SEABROOK STATION
Engineering Office

February 14, 1986
SBN-945
T.F. B7.1.2

Subject: Meeting Notes Instrumentation and Control Systems Branch

We have enclosed revised ICSB meeting minutes that consolidate our responses to RAIs 420.05 to 420.81. This enclosure includes revisions to RAIs 420.8, .10, .12, .15, .23, .45, .47, .48, .54, .59, .68, .73, .76, and .81 that were discussed at the ICSB meeting held November 20 and 21, 1985. It also includes updated status of the remaining outstanding and confirmatory issues. This status includes the tabulation of the FSAR changes and revised project documents that provide formal documentation of the commitments made in our RAI responses. Copies of the project documents listed will be available in our Bethesda licensing office for Staff review and information.

FIGURE 7.2-1 SHEET 16

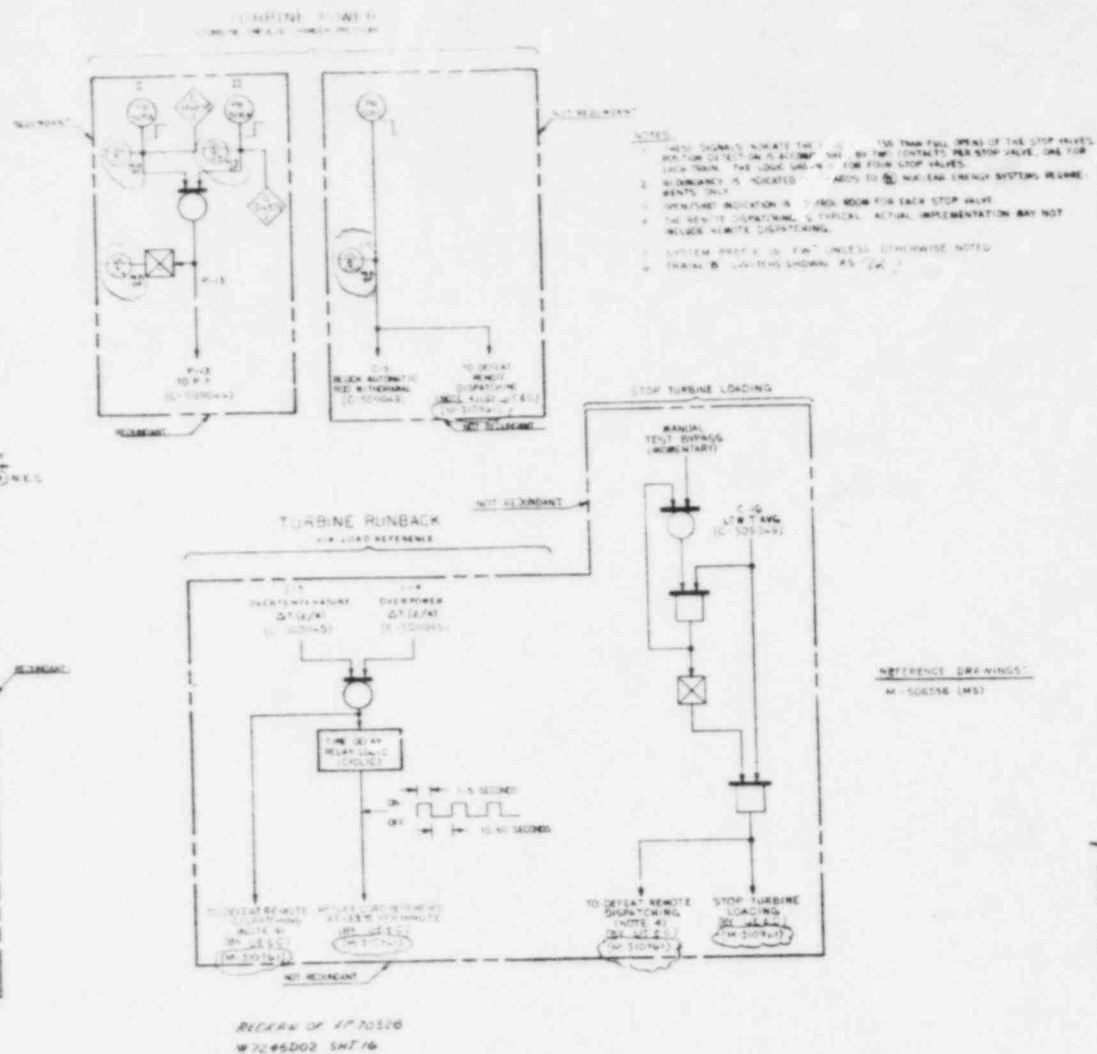
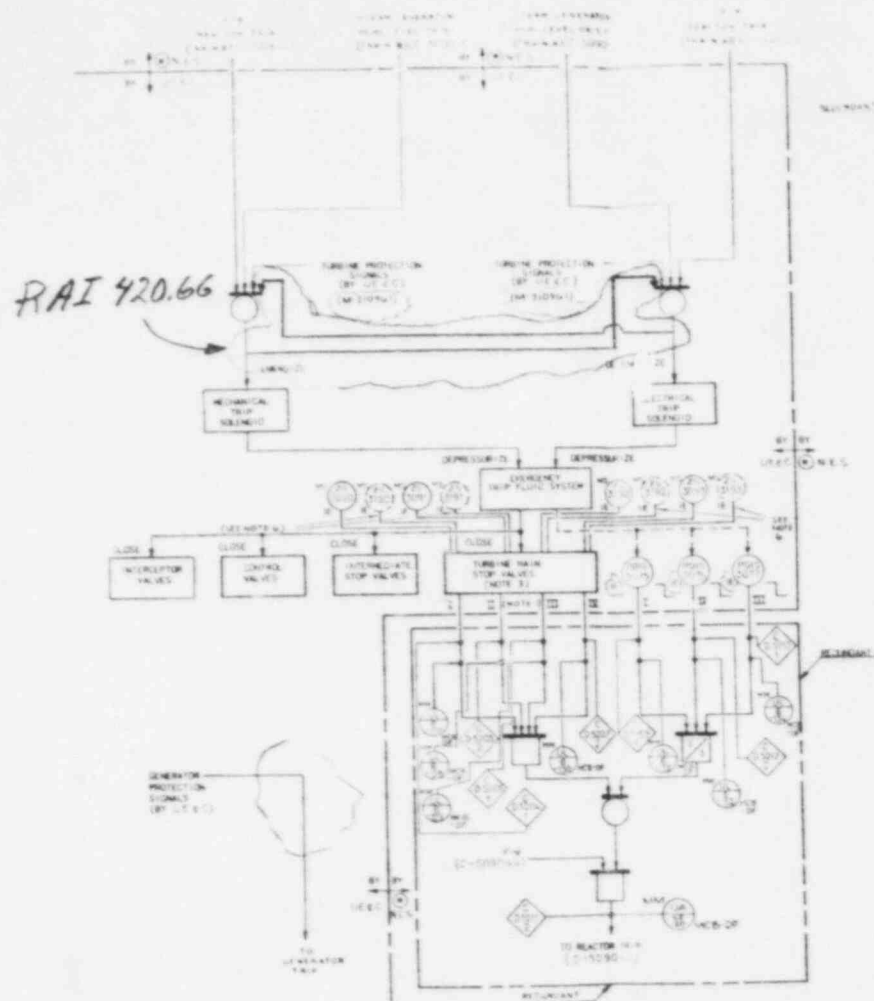
RESPONSE: As shown on FSAR Figure 7.2-1, Sh. 16, redundant P-4 (reactor
2/86 trip breakers open) signals are input to the two turbine trip
circuits. One circuit energizes the mechanical trip solenoid, the
other de-energizes the electrical trip solenoids to depressurize
the Emergency Trip System and close the turbine valves. We have
marked up FSAR Figure 7.2-1, Sh. 16, to show the cross-trip
circuits provided so that both trip circuits will be activated if
either train of reactor trip breakers is opened. FSAR
Figure 7.2-1, Sh. 16, will be revised in a future amendment.
Details of the Trip System is provided in the following documents:

The Westinghouse NSSS and General Electric turbine generator at
Seabrook are essentially similar to the design at Millstone 3 and
Vogtle that have recently been reviewed and accepted by the NRC
(see Figure 7.2-1, Sh. 16, in the Millstone 3 and Vogtle FSARs).
